DHCD -- Division of Building and Fire Regulation
2009 Code Change Cycle

COMPILATION DOCUMENT
(of all code changes received with staff evaluations)

PART III

Code Change Number: C-1024.1(a)

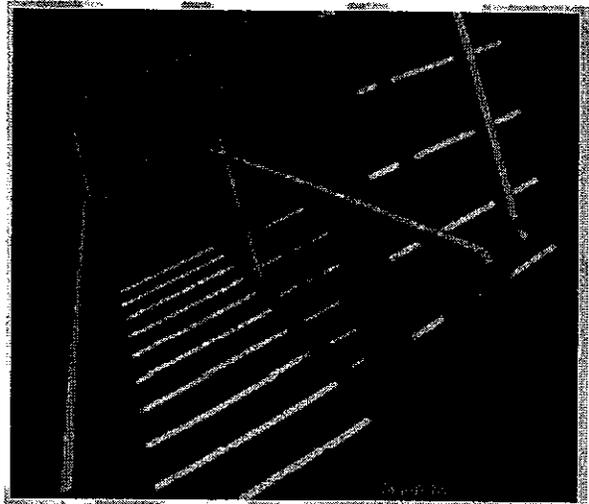
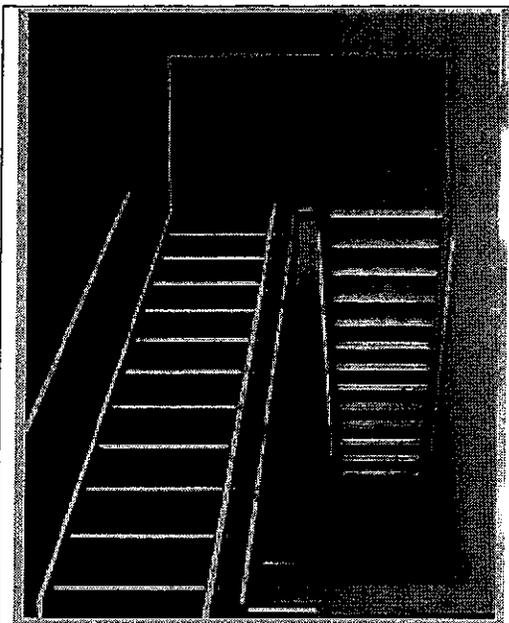
1024.1 General. *Approved* luminous egress path markings delineating the exit path shall be provided in buildings of Groups A, B, E, I, M and R-1 having occupied floors located more than 75 ~~420~~ 128 016 feet (~~22 860~~ 128 016 mm) above the lowest level of fire department vehicle access in accordance with Sections 1024.1 through 1024.5.

It is my understanding that this new code section was included as a result of the 9/11 reports and/or recommendations. Given that the loss of life that day mostly involved "super" high rises, it appears this section is more suited to much taller buildings. Given the definition of a "high rise," these requirements could potentially be required for a *five-story* building, which is a far cry from those buildings affected on 9/11.

However, the biggest concern is the durability of the required markings and the continued maintenance (and associated costs) involved for what could ultimately affect numerous multi-story buildings throughout the Commonwealth. It seems inevitable that the markings on the edge of the steps, edge of the landings, and almost certainly the markings applied to the *top* of the handrails, will fail or wear off those surfaces, and will require constant repair or replacement. Worse – nothing is done to repair or replace the defective markings – which could lead to unanticipated consequences (e.g., tripping over loose markings, or getting a person's hand stuck on the markings that become loose on the handrails).
